TO: Mercedes-Benz Dealer Principals, General Managers, Sales Managers, Service Managers, Parts Managers	FROM: Anthony Washington, Senior Manager, Regulations and Certifications
Re: Launch Recall Campaign Notification Model Sprinter 907 Model Years 2021-2023 Replace Fuel Delivery Module	DATE: October, 2023

Campaign No. 2023090004 October, 2023

SUBJECT: **Model 907 Sprinter, Model Year 2021-2023**
Replace Fuel Delivery Module

Order No. V-RC-2023090004

D47.20-A027-03

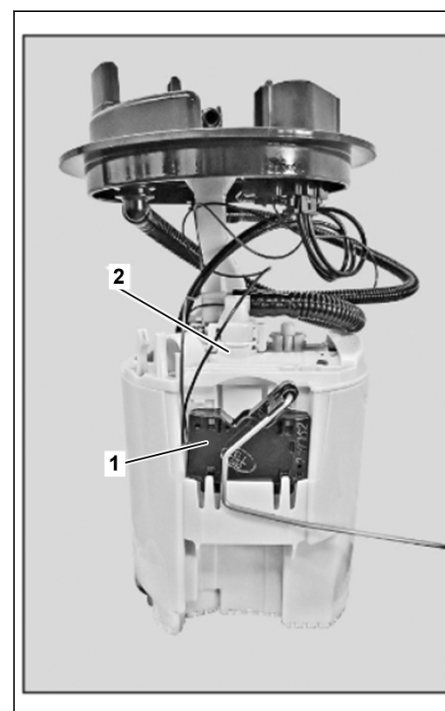
- 1 *Fuel tank fill level sensor*
- 2 *Fuel feed module*

Check		
1	Check whether vehicle is affected by measure.	<p> If the vehicle is affected by the service measure, pass on information to the vehicle owner that during a workshop visit for this service measure, the fuel tank must only be filled to a maximum of 20%.</p> <p> A filling of 20% corresponds to 2 bars in the fuel display.</p>	
	Replace		
2	Position air extraction system in working area and switch on.	<p> For example, see WS47.00-P-0039B.</p>	
3 AR	Replace fuel delivery module (2).	<p> Removal: Contrary to the method described, the fuel hose (3) does not need to be removed.</p> <p>The filler neck (4) is only detached from the body and remains on the fuel tank.</p> <p> Dispose of removed component parts that are not reused properly. Observe the applicable legal requirements and specifications of the relevant country.</p> <p>If the new part is not equipped with a fill level sensor (1),</p> <p style="text-align: center;">↓</p> <p>the fill level sensor (1) must then be modified.</p>	AR47.20-D-7000TSC

D47.20-A029-76

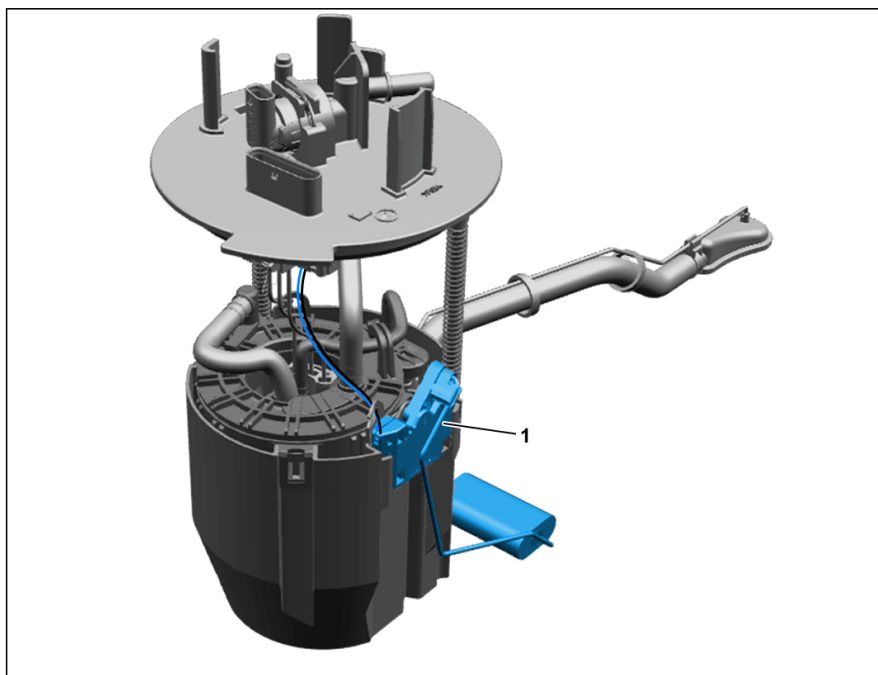
SM47.20-D-0027-02SG	Modify fill level sensor of fuel delivery module (code: VS3KRAPUMP, acc. no.: 47 902 07)		
---------------------	--	--	--

1 Fill level sensor
